# FINAL DRAINAGE REPORT FOR ZINDORF — MCDANIEL'S SUBDIVISION

PCD FILE NO. MS-22-006

July 2023

**McDaniels' Subdivision  
Floodplain Evaluation**

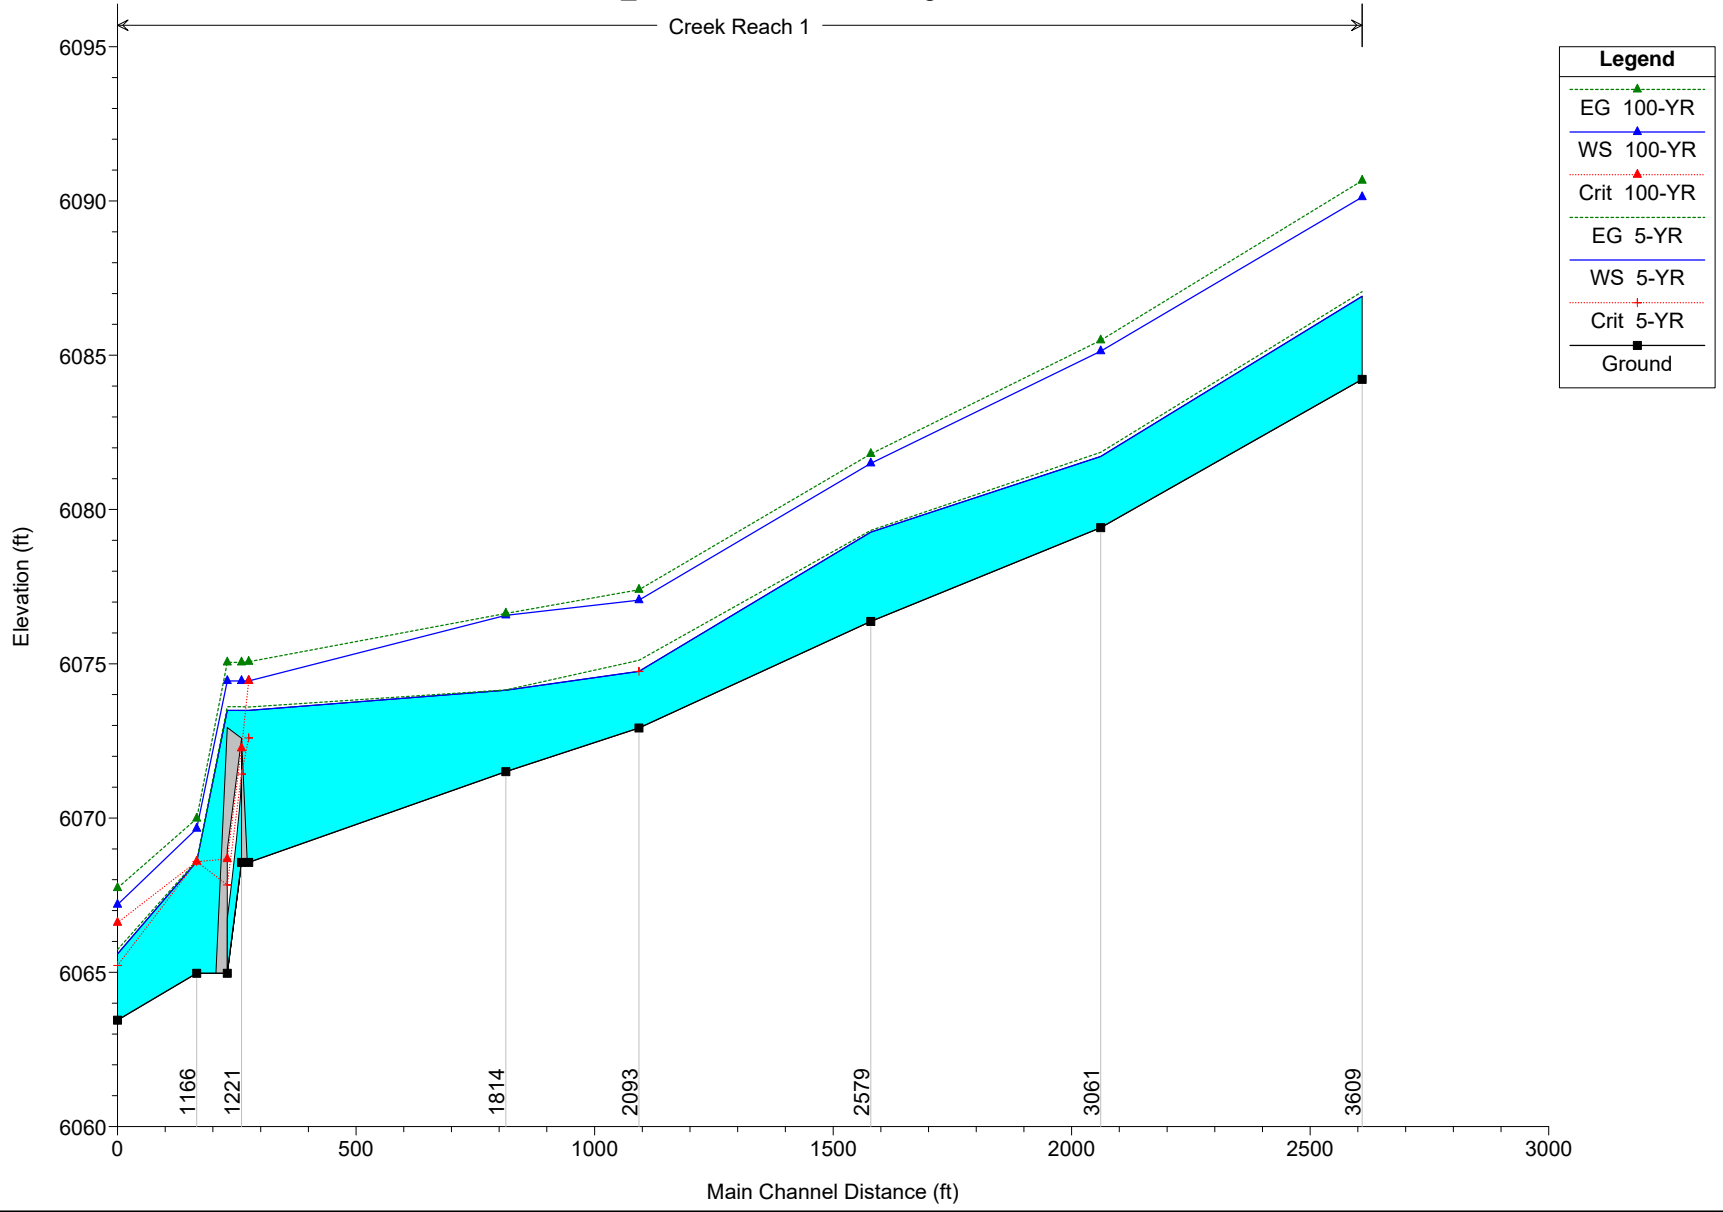
Label sections. Be sure to show and label sections that correspond to those shown on FEMA floodplain map.

Flow rate  
through  
project  
reach

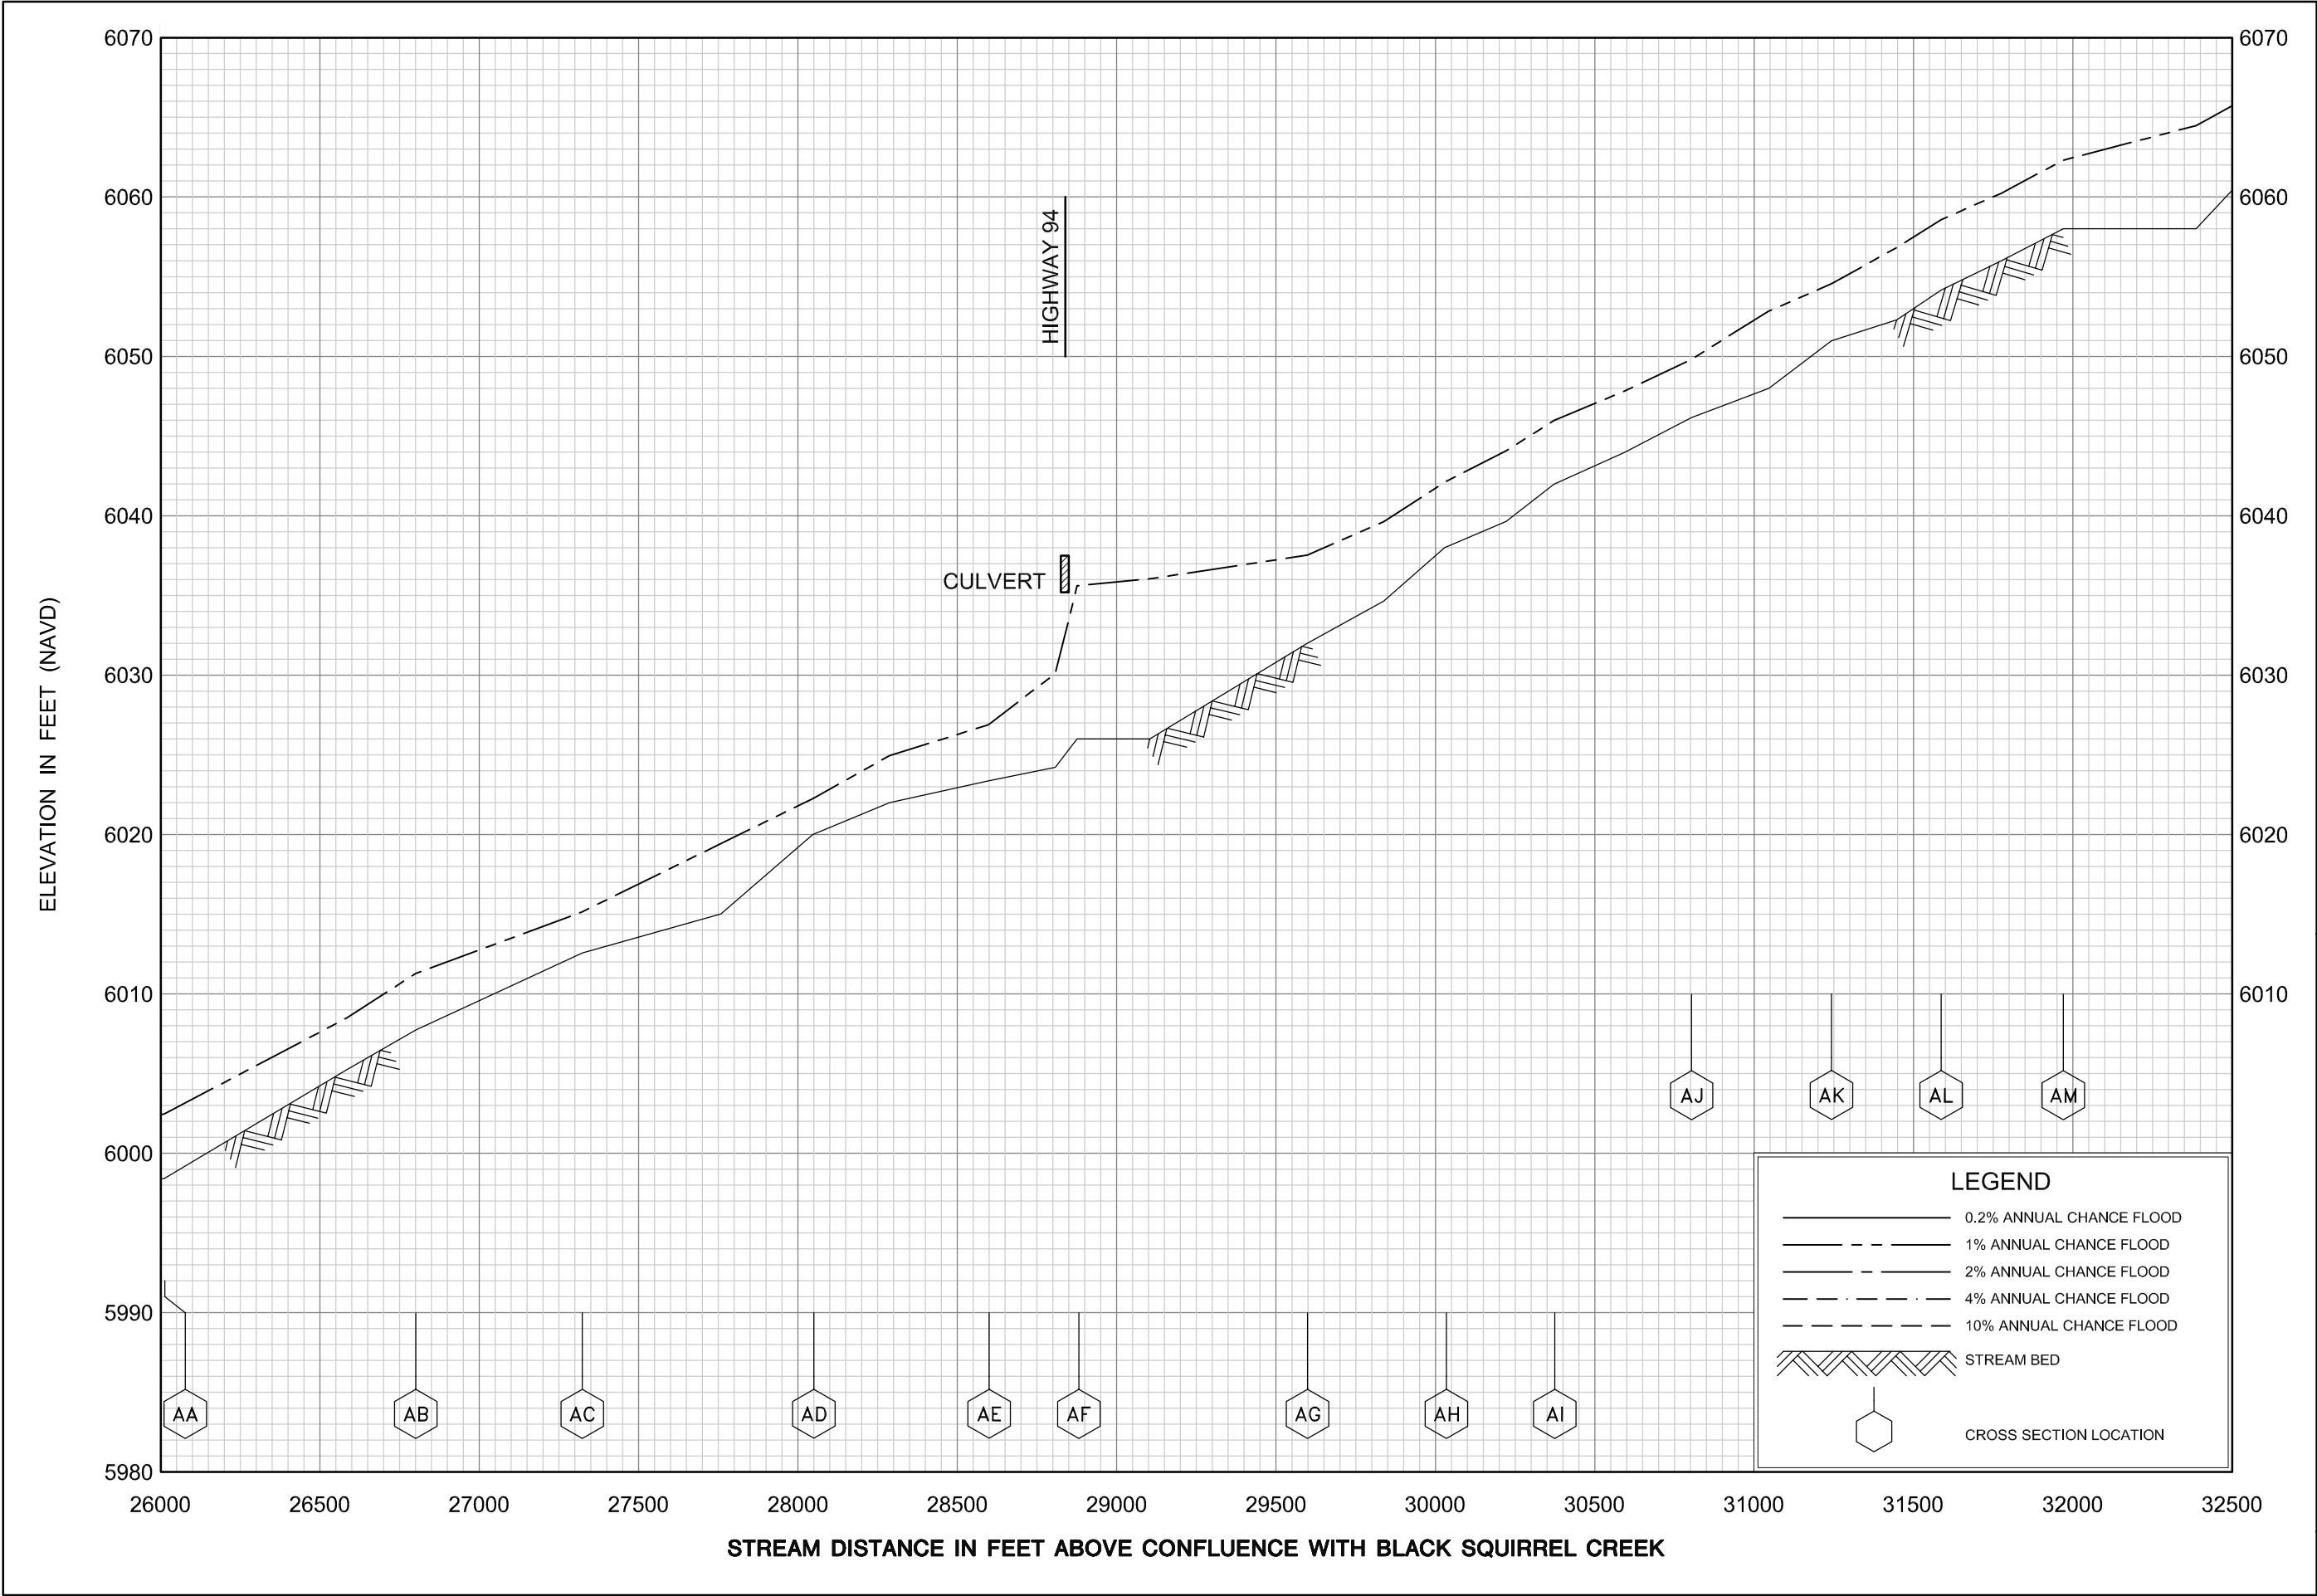
FEMA flow in channel is 7019 cfs. Where was 3200 cfs obtained?
